# RF TEST REPORT

**Applicant** Kizy Tracking SA  
**FCC ID** 2AGPEWT2  
**Product** Tracker  
**Model** K-2  
**Report No.** R1903A0135-R1  
**Issue Date** April 25, 2019

**K-2 (Report No: R1903A0135-R1) is a variant model of K-2 (Report No: RXA1712-0426RF02R2). Test values partial duplicated from Original for variant. WCDMA II was selected as the worst condition. There is only tested Radiates Spurious Emission of WCDMA II for variant in this report. The detailed product change description please refers to the ANNEX B.**

### K-2 Difference statement

1. Appearance change:

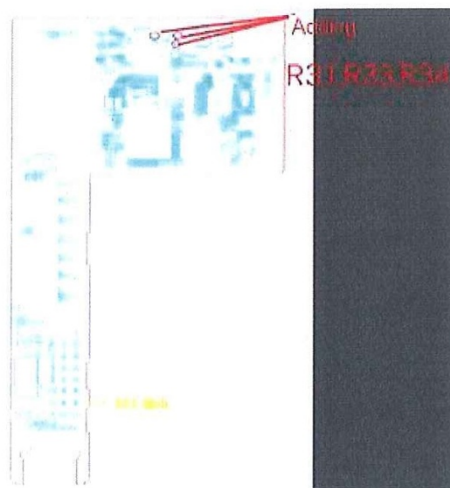
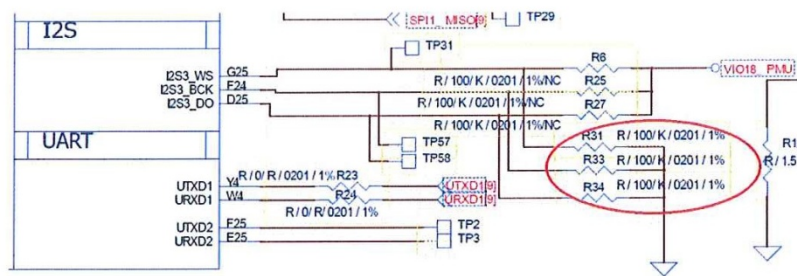
There are no changes in the material, only the appearance changes: as shown below

##### 1. Added 3 resistors to confirm the version,R31,R33,R34,

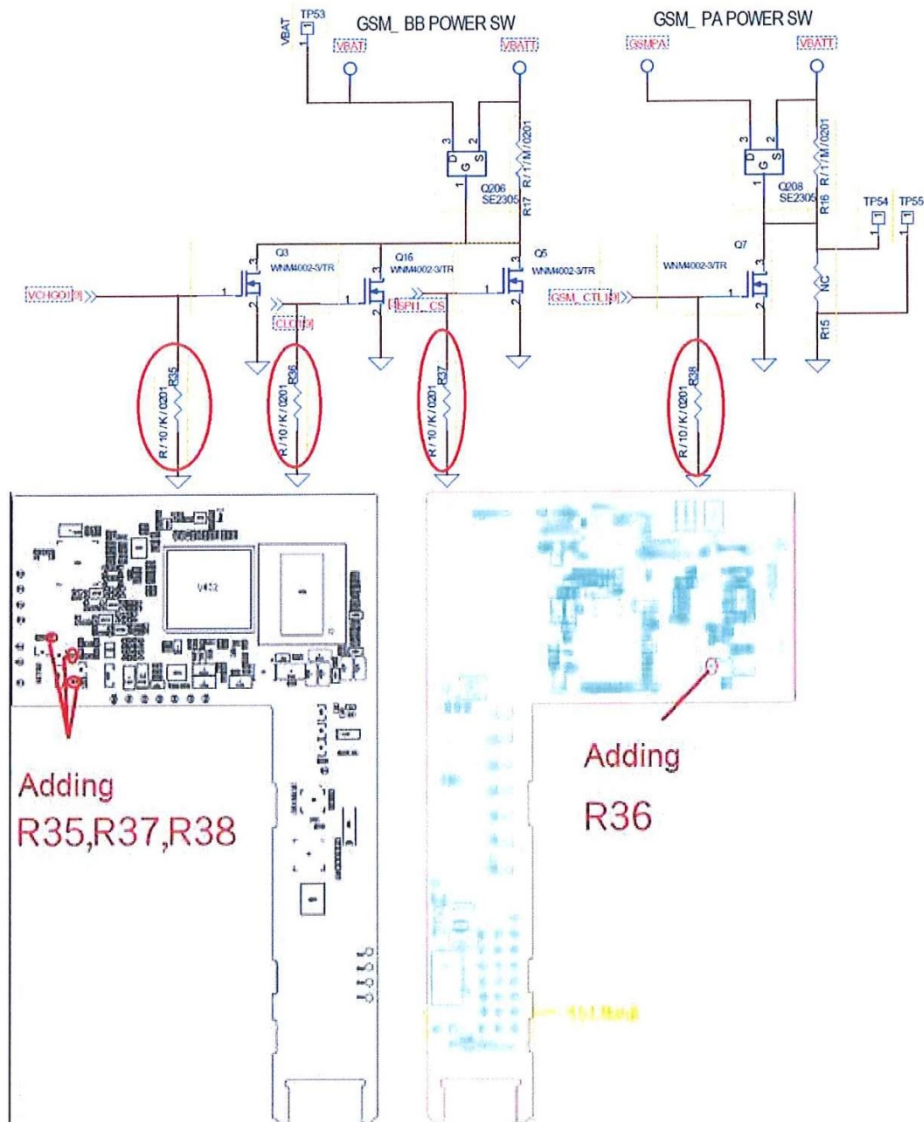
1	WT2N	Hardware Ver. Control	<p>Add pull low resistance to check HW Ver. MTK U402 I2S3_WS(G25), I2S3_BCK(F24),I2S3_DO(D25), PCB version,PULL HIGH100KΩ,VIO18_PMU, with PULL LOW 100KΩ to GND Actually the pieces are: U402_I2S3_WS(G25),PULL LOW U402_I2S3_BCK(F24),PULL LOW U402_I2S3_DO(D25),PULL LOW</p>
---	------	-----------------------	--

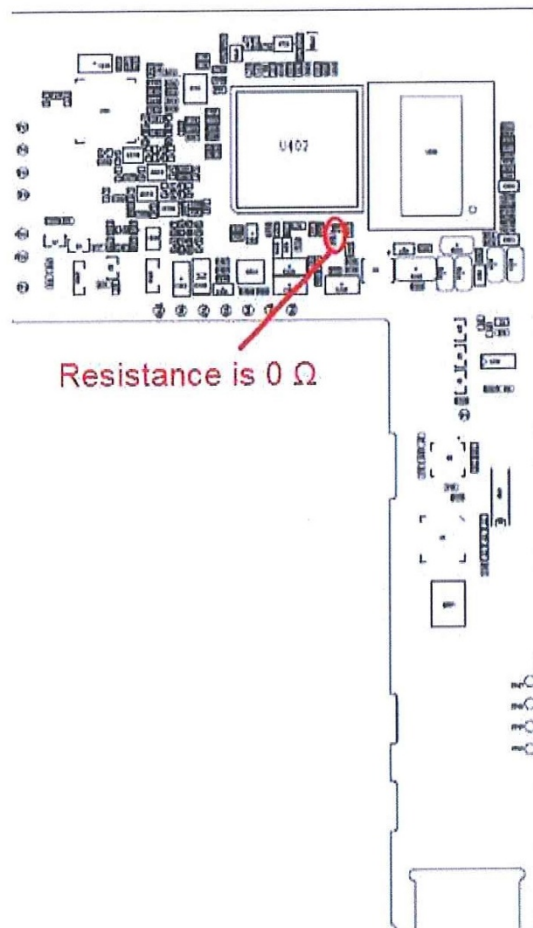
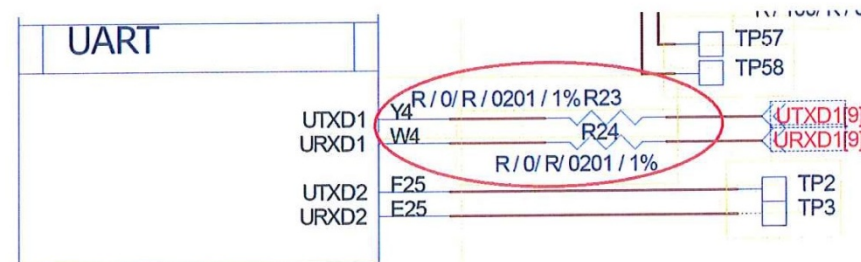
2	WT2N	Power Leakage When Off Switch	<p>Add pull low resistance to shut down VBATT power Because it cannot be completely shut down, it must be</p> <ol style="list-style-type: none"> <li>1.Q3' s G PIN parallel <math>10K\Omega</math> to GND</li> <li>2.Q160' s G PIN parallel <math>10K\Omega</math> to GND</li> <li>3.Q5' s G PIN parallel <math>10K\Omega</math> to GND</li> <li>4.Q7' s G PIN parallel <math>10K\Omega</math> to GND</li> </ol>
---	------	----------------------------------	--

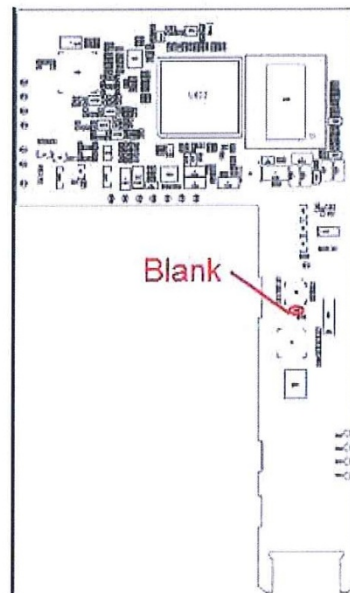
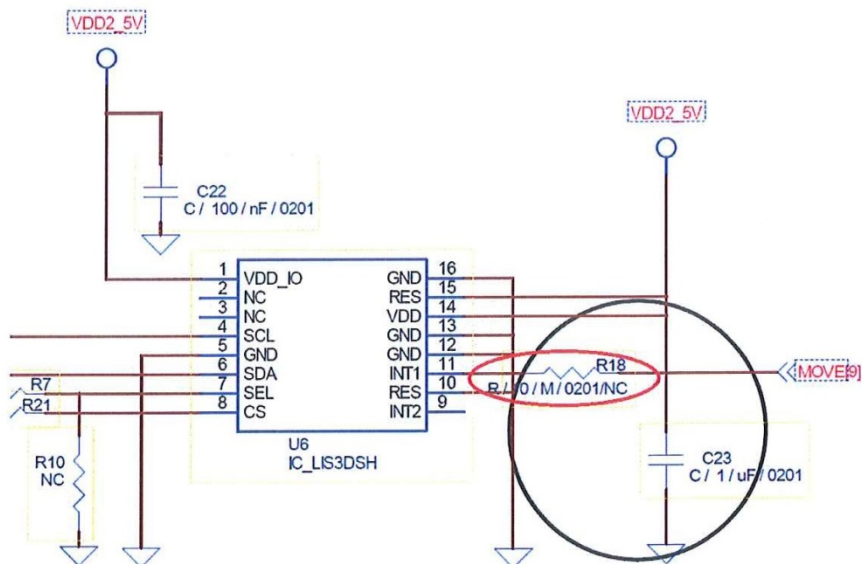
3	WT2N	UART Slew Rate	Resistance value change to $0\Omega$ For UART R23 and R24 Change the resistance to $0\Omega$
---	------	----------------	---

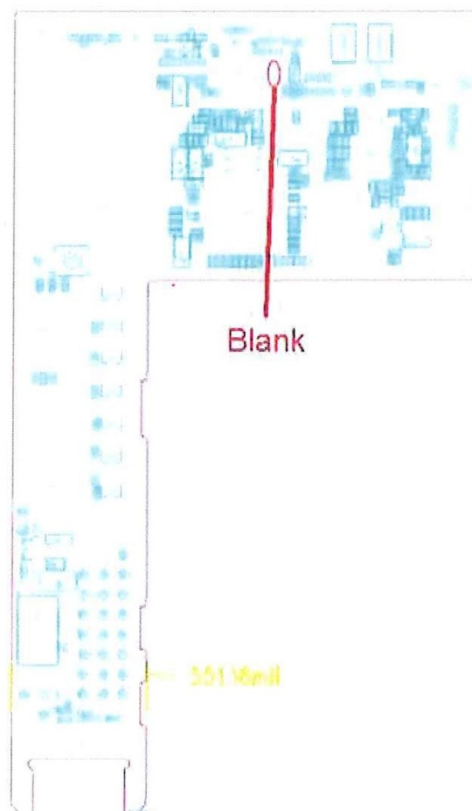
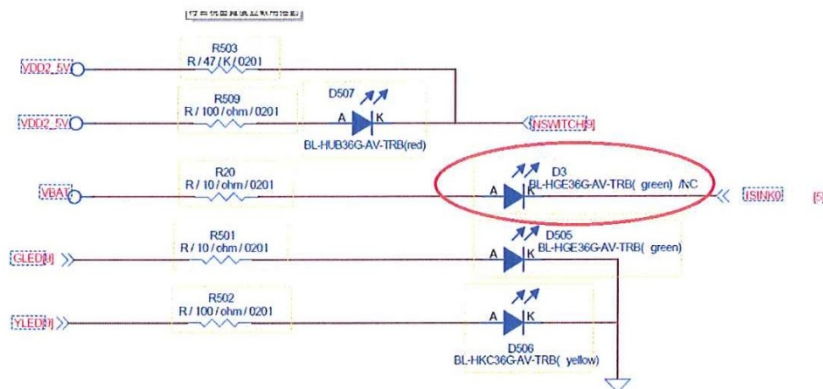
4	WT2N	Accelerometer malfunction	Take off R18
---	------	---------------------------	--------------

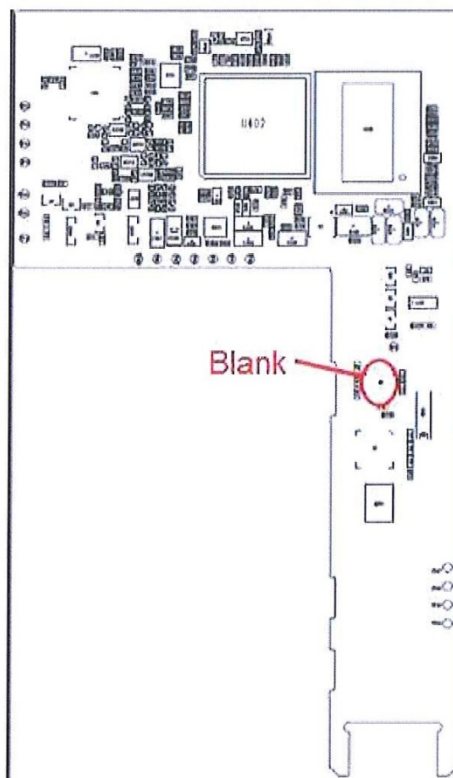
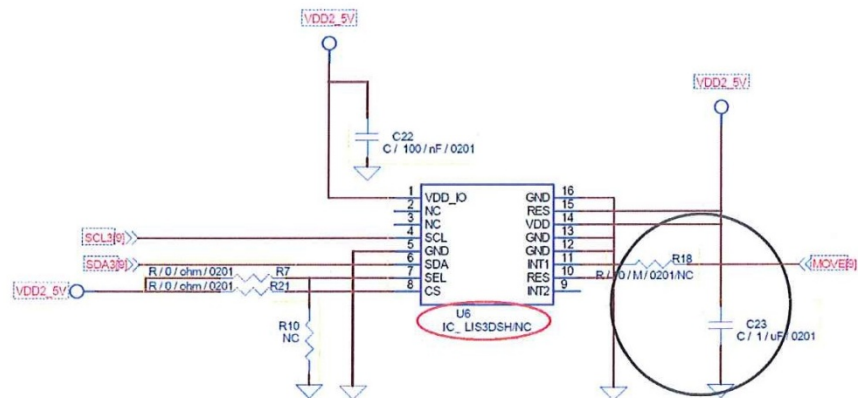
5	WT2N	4th LED removed	Take off D3
---	------	-----------------	-------------
